RENESAS TECHNICAL UPDATE

製品分類	トランジスタ	発行番号	TN-WTR-A005A/J	Rev.	第1版
題名	WPAK テーピング仕様変更		情報分類	梱包仕様変更	
適用製品	WPAK 外形一部製品 (2500pcs/reel 仕様の WPAK 品)	対象ロット等	関連資料

4.1 リーダーテープ仕様

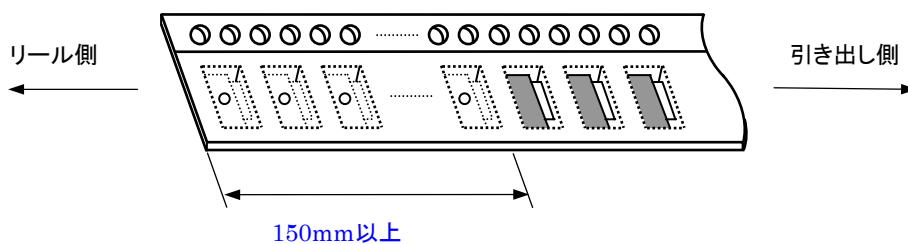
1.1 リーダーテープの寸法を 360mm 以上から 150mm 以上に変更します。
